SUBJECT: Grand Gulf Nuclear Station
Unit 1
Docket No. 50-416
License No. NPF-29
Supplemental Information for PCOL-90/03
Revision 2
AECM-90/0142

Responses to NRC Staff Feedback on AECM-90/0111

EVALUATION OF THE EFFECTIVENESS
OF RHR SHUTDOWN COOLING AND ADHRS
FLOWPATHS AND FLOWRATES FOR REACTOR
COOLANT CIRCULATION AND HEAT REMOVAL
IN OPERATIONAL CONDITIONS 4 AND 5

Figure 1. RHR SDC Flow Paths with Return via Feedwater Line

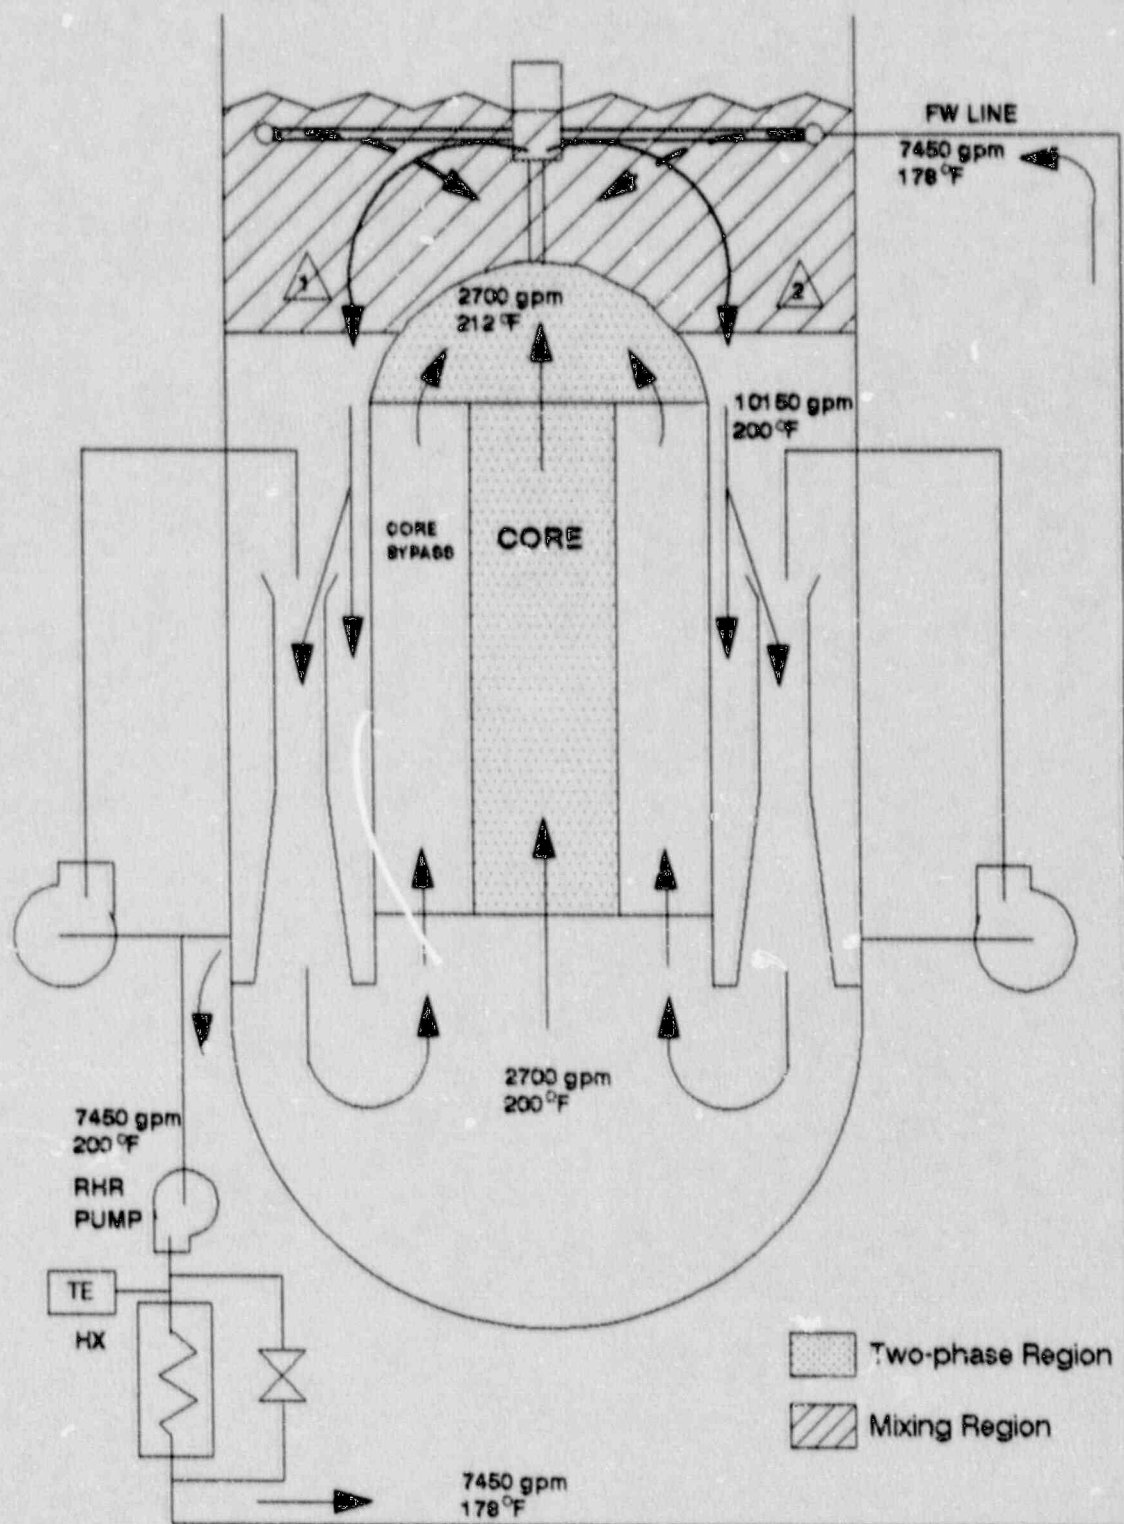
Figure 1 illustrates the coolant flowpaths during OC 4 due to the induced (pumped) RHR flowrate and the natural circulation flowrate developed as a result of decay heating of the reactor core water and the density differences between the coolant inside the shroud and that in the downcomer annulus. As shown, the cooling water supplied by RHR establishes a flowpath from the spray nozzles on the feedwater spargers through the entire downcomer annulus and exits the vessel via the recirculation outlet nozzle. The reactor coolant heated in the core region establishes a natural circulation flowpath (UFSAR Section 4.4) which forces the water from the core inside the shroud up through the steam separator extension piping and out the bottom end of the steam separator standpipes where it is mixed with the cooling water exiting the feedwater spargers. This natural circulation flowpath is assured at all times by maintaining the Reactor Water Level at or above Reactor Water Level 3 trip function setpoint, which is well above the bottom openings of the steam separator (by at least 2 feet).

For this method of decay heat removal, the mixing region for the reactor coolant and the cooling water from RHR is outside the shroud and above the jet pumps (areas 1 and 2 on Figure 1). Mixing in this region is enhanced for two reasons. The first is the cooling water flow out of the feedwater spargers is directed radially inward toward the exit point of the warmer water rising through the steam separator. Secondly, the warmer water rising from inside the shroud is directed

Figure 2. RHR SDC Flow Paths with Return via LPCI Line

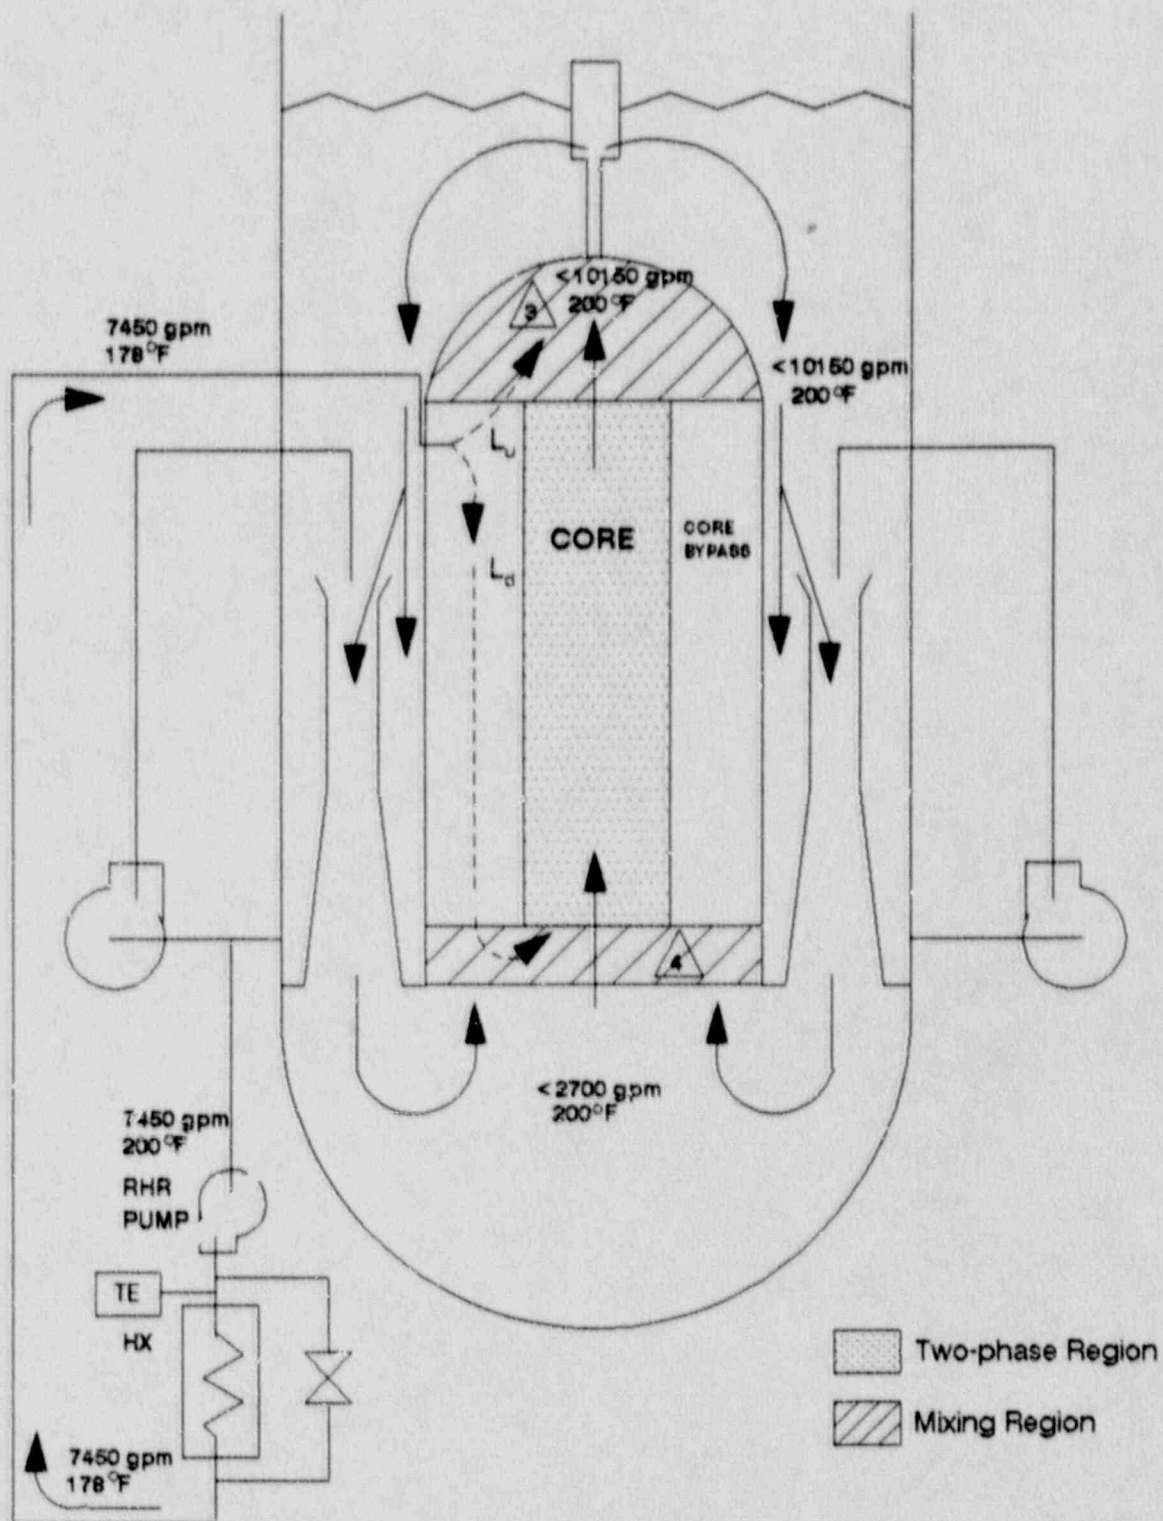
Figure 2 describes the coolant flowpaths established for RHR during OC 4 with the vessel return via the LPCI injection line. Although the LPCI injection flowpath reenters the vessel at only one location, whereas feedwater enters at three and is radially distributed, the LPCI flow deflectors inside the shroud radially distributes the injected cooling water. As opposed to the feedwater injection flowpath where the thermal mixing region is in the volume outside the shroud and above the jet pumps, cooling water injection directly inside the shroud moves the primary mixing region into the immediate vicinity of the core (areas 3 and 4 on Figure 2). For steady state thermal conditions, all of the mixing and thus all of the heat exchange occurs inside the shroud. Based on an independent evaluation by General Electric, complete mixing is obtained inside the shroud for this injection point. This mixing is achieved by countercurrent flows throughout the core region. One flow path (L_u on Figure 2) is upward through the core bypass region and into the plenum directly above the core where it interacts with and cools the heated water exiting the core. Another flowpath (L_d on Figure 2) is downward through the core bypass region where it is mixed with the lower plenum fluid. With sufficient decay heat, the L_d component of flow exiting the core into the lower plenum would be recirculated back up into fuel channels. At low decay heat levels, a reverse flowpath would be established through the lower plenum and up the jet pumps into the downcomer annulus for a portion of the overall coolant flow. In both situations, all of the coolant circulation passes through the shroud interior.

Using the same reactor and shutdown cooling conditions evaluated for the feedwater flowpath, the expected coolant temperatures and estimated maximum flowrates for each of the vessel regions are shown in Figure 2. These values demonstrate that a very effective decay heat removal process exists for RHR injection via LPCI. When compared with the feedwater injection flowpath, the shroud exit water temperatures are lower for the LPCI flowpath and the bulk average water temperatures for the entire reactor vessel are more evenly distributed.

As shown in Figure 2, the temperature of the fluid entering the recirculation suction and continuing to the RHR heat exchangers where the temperature is measured is the same as that of the fluid entering the jet pumps. The reactor coolant temperature is approximately constant (excluding negligible heat transfer through the vessel walls and piping systems) throughout the downcomer annulus, lower plenum under the core plate, and the steam separator region outside the shroud. Although the fluid temperatures inside the shroud can vary from a minimum value equal to that of the injected cooling water (e.g., 178°F) to a maximum value equal to the saturation temperature at the bottom of the fuel channels (e.g., 245°F at normal water levels corresponding to a static pressure head of 27.3 psia), the average reactor coolant temperature inside the shroud cannot be greater than that outside the shroud since all of the coolant circulates from the shroud interior to the exterior regions. Thus, effective heat removal from the core region and representative temperature monitoring are maintained by coolant injection directly inside the shroud.

Figure 3. ADHRS Flow Paths with Return via LPCI Line

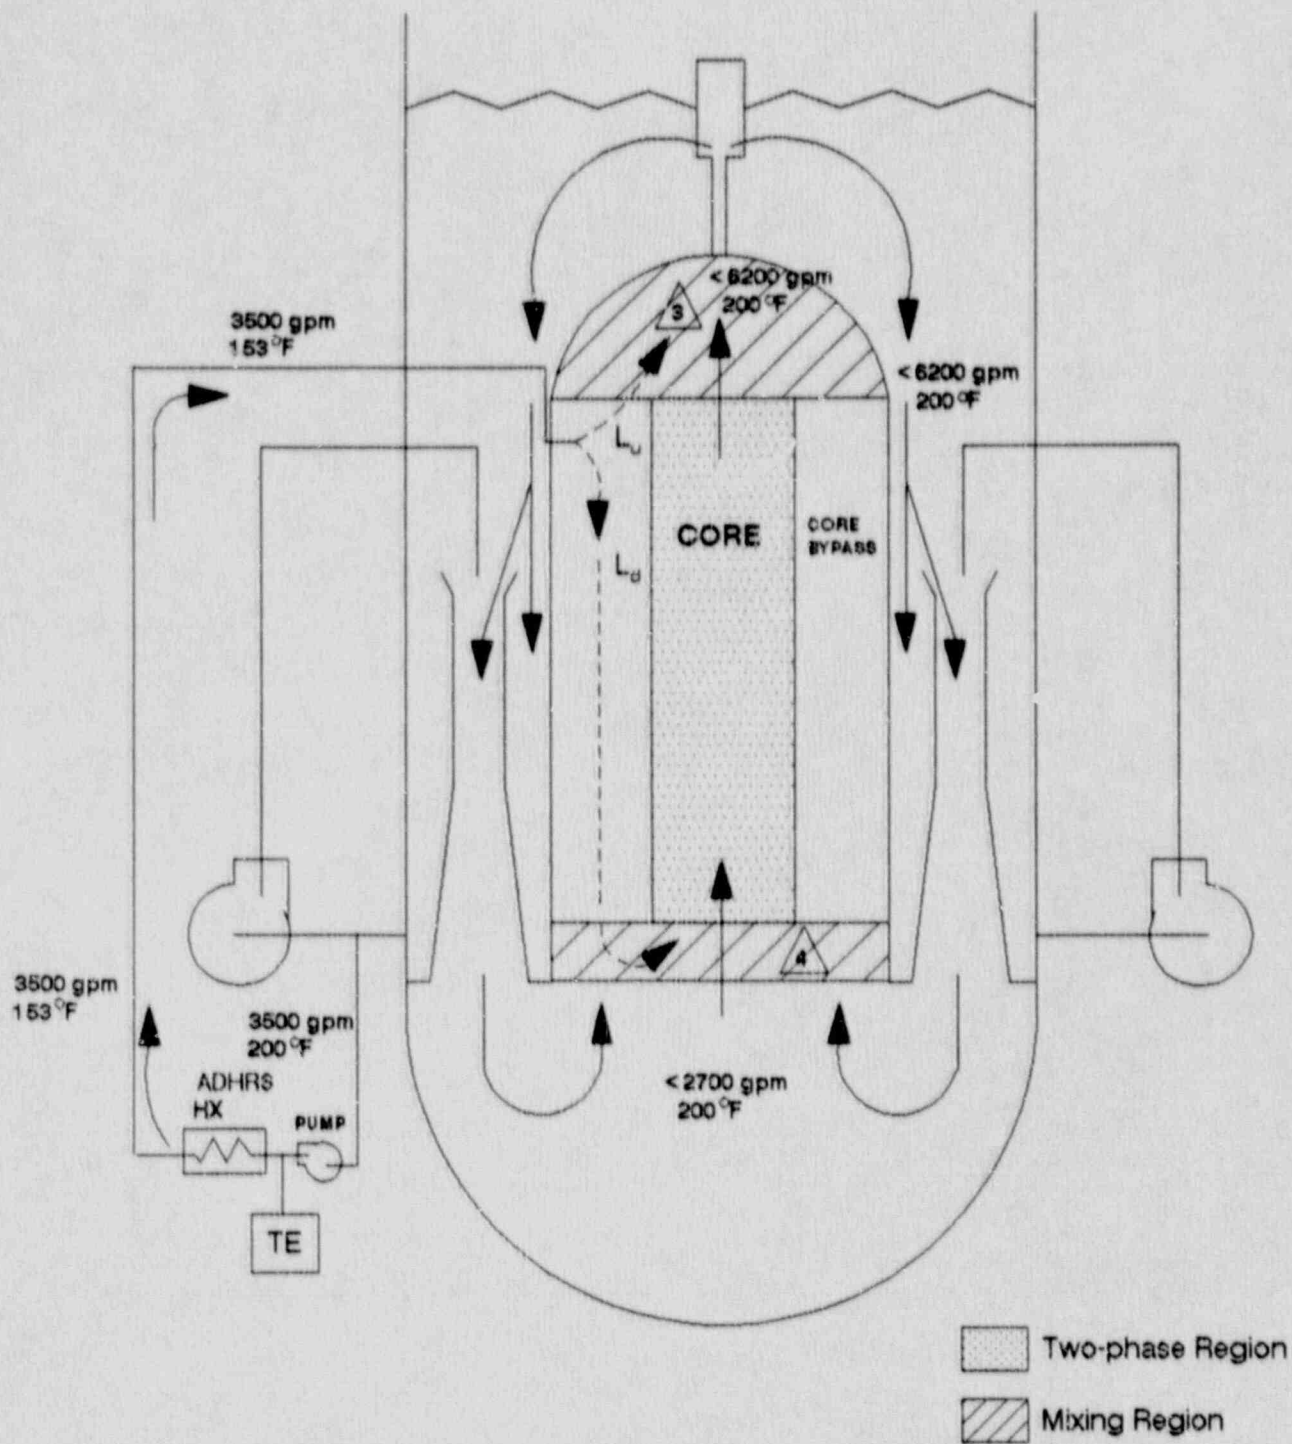
The flowpath for ADHRS is essentially the same as that for an RHR shutdown cooling system with coolant injection via LPCI (see Figure 3). The only thermal-hydraulic difference between these two methods of decay heat removal is that ADHRS varies the heat removal capacity by varying the system flowrate. While the RHR flowrate is normally maintained constant at approximately 7500 gpm, the ADHRS flowrate is normally controlled within a range of 1000 to 3600 gpm. These flowrates were established based on the heat removal requirements for the system with the reactor in either OCs 4 or 5 and 24 hours after shutdown decay heat loads (approximately 79 MBtu/hr). As with RHR via LPCI, complete mixing of the ADHRS cooling water and heated reactor water exiting the core is obtained by injection directly inside the shroud. Figure 3 provides the expected coolant temperatures and estimated maximum flowrates for each of the vessel regions for ADHRS. These values demonstrate that effective core cooling is obtained even for the lower ADHRS flowrates.
